[Docket No. 2003-NE-52-AD Amendment 39-13410; AD 2003-24-12R1]

Airworthiness Directives; Pratt & Whitney JT9D-3A, -7, -7A, -7F, -7H, -7AH, and -7J Turbofan Engines**AGENCY:** Federal Aviation Administration (FAA), DOT.**ACTION:** Final rule; request for comments.

2003-24-12R1 Pratt & Whitney:
Amendment 39-13410. Docket No. 2003-NE-52-AD. Revises AD 2003-24-12, Amendment 39-13381.

Figure 1

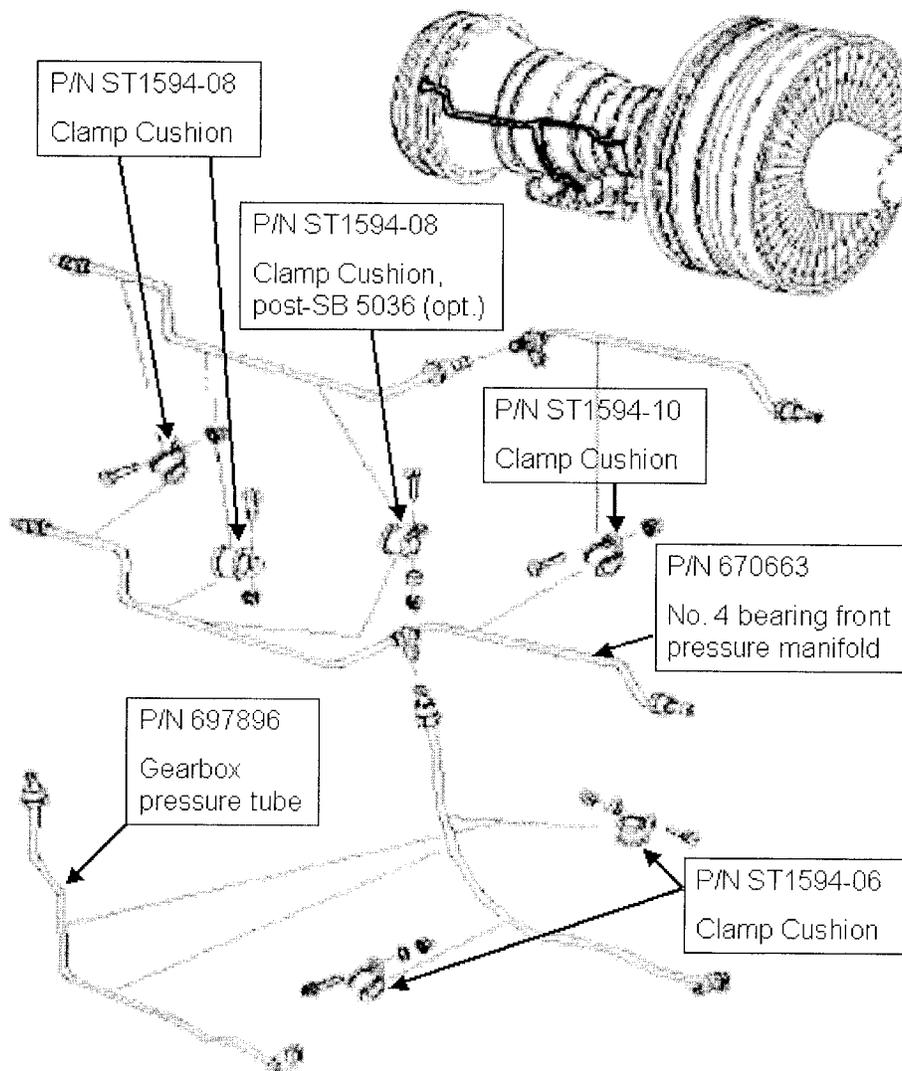
Since that AD was issued, errors in the depicted clamping configuration have been found. The clamping configuration must be correct to ensure that AD compliance can be achieved. Also, an operator has requested that as an option to inspecting dented tubing by passing a ball bearing through the tube, to add dent depth limit criteria for each specific part number tube. The manufacturer supports this optional method and we have added it to the AD. This method avoids having to disconnect the tube from the engine.

(d) This AD results from the need to correct errors in depicted clamping, to ensure that AD compliance can be achieved. The actions specified in this AD are intended to prevent engine fires caused by failed gearbox pressure tubes or failed No. 4 bearing front pressure manifolds.

(f) Visually inspect the clamp assemblies, P/Ns ST1594-06, ST1594-08, and ST1594-10, (see Figure 1 of this AD) that attach the gearbox pressure tube and the No. 4 bearing front pressure manifold to the engine. Replace clamp assemblies before further flight that are rejected by any of the following rejection criteria:

(g) If one or more clamp assemblies are rejected as described in paragraph (f) of this AD, or out of position or missing (see Figure 1 of this AD), clean any debris and oil from the outer surface of the gearbox pressure tube and No. 4 bearing front pressure manifold and visually inspect the tube and manifold. Repair or replace the affected tube or manifold before further flight if it is rejected by any of the following rejection criteria:

(h) Ensure that the gearbox pressure tube, No. 4 bearing front pressure manifold, and clamp assemblies are properly positioned, before further flight, as shown in Figure 1 of this AD.
